# Access Compliance Report

## Public Rights-of-Way

Intersection ID: 9901	Main Street: HOOD_RD	Cross Street: KENTSHIRE_LN	Location:	N
ADA ID: 8E9E64DE1481	Ramp Type: Directional1	Initial Pass/Fail: Fail	Overall Compliance: No	Severity Score: 13.75

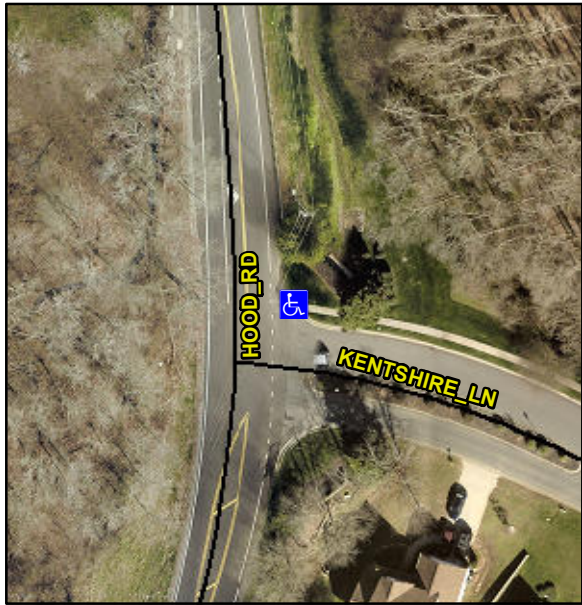
Codes/Mitigation Info/Possible Solution			Field Measurements/Component Compliance								
	Possible Solutions:		<b>Compliance</b>			<b>Description</b>			<b>Data</b>		
	<b>Remove &amp; Replace Entire Ramp.</b>		<b>N/A</b>	Ramp Length (in)		<b>100.0</b>	<b>N/A</b>	Grade Break?		<b>N/A</b>	
			<b>Yes</b>	Ramp Width (in)		<b>48.0</b>	<b>N/A</b>	Grade Break Slope (%)		<b>0.0</b>	
			<b>No</b>	Ramp Slope (%)		<b>11.1</b>	<b>N/A</b>	Grade Break XSlope (%)		<b>0.0</b>	
			<b>No</b>	Ramp XSlope (%)		<b>4.3</b>					
			<b>N/A</b>	Flare Type LT		<b>N/A</b>	<b>N/A</b>	Flare Type RT		<b>N/A</b>	
			<b>N/A</b>	Flare Slope LT (%)		<b>N/A</b>	<b>N/A</b>	Flare Slope RT (%)		<b>0.0</b>	
			<b>N/A</b>	Flare Traversable LT?		<b>N/A</b>	<b>N/A</b>	Flare Traversable RT?		<b>N/A</b>	
			<b>N/A</b>	Landing Length (in)		<b>0.0</b>	<b>N/A</b>	DWS Provided?		<b>N/A</b>	
			<b>N/A</b>	Landing Width (in)		<b>0.0</b>	<b>N/A</b>	DWS Contrast?		<b>N/A</b>

<p>Surveyor Notes:</p> <p><b>N/A</b></p>			<b>N/A</b>	Landing Slope (%)		<b>0.0</b>	<b>N/A</b>	DWS Length (in)		<b>N/A</b>	
			<b>N/A</b>	Landing X Slope (%)		<b>0.0</b>	<b>N/A</b>	DWS Full Width?		<b>N/A</b>	
			<b>N/A</b>	Landing Curb? (Y/N)		<b>N/A</b>	<b>N/A</b>	DWS Offset LT (in)		<b>N/A</b>	
			<b>N/A</b>	Shared Landing?		<b>N/A</b>	<b>N/A</b>	DWS Offset RT (in)		<b>N/A</b>	
			<b>N/A</b>	Gutter Ponding?		<b>0.0</b>	<b>N/A</b>	Gutter Slope (%)		<b>N/A</b>	
			<b>N/A</b>	Gutter Lip Ht (in)		<b>2.0</b>	<b>N/A</b>	Gutter X Slope (%)		<b>N/A</b>	
			<b>N/A</b>	Painted X Walk1?		<b>No</b>		Road Slope (%)		<b>2.3</b>	
				X Walk 1 Direction		<b>To S</b>		Road X Slope (%)		<b>2.7</b>	
				X Walk 1 Width (in)		<b>N/A</b>		Clear Space?		<b>N/A</b>	
				X Walk 1 Slope (%)		<b>2.3</b>	<b>N/A</b>	Clear Space to XWalk (in)		<b>N/A</b>	
<p>PROW/ADA:</p> <p><b>R304.2.2, R304.5.3</b></p>				X Walk 1 X Slope (%)		<b>2.7</b>	<b>N/A</b>	Storm Grate/Utility Hazard?		<b>N/A</b>

<b>N/A</b>	Ramp inside XWalk1?		<b>N/A</b>		Storm Grate/Utility Type			
			<b>N/A</b>	Any Obstructions?		<b>N/A</b>				<b>N/A</b>	
				Obstruction Type			<b>Yes</b>	Surface Condition? (G/P)		<b>Good</b>	
							<b>N/A</b>	Curb Slope (%)		<b>15.8</b>	
Total Cost:			\$	<b>1600.00</b>
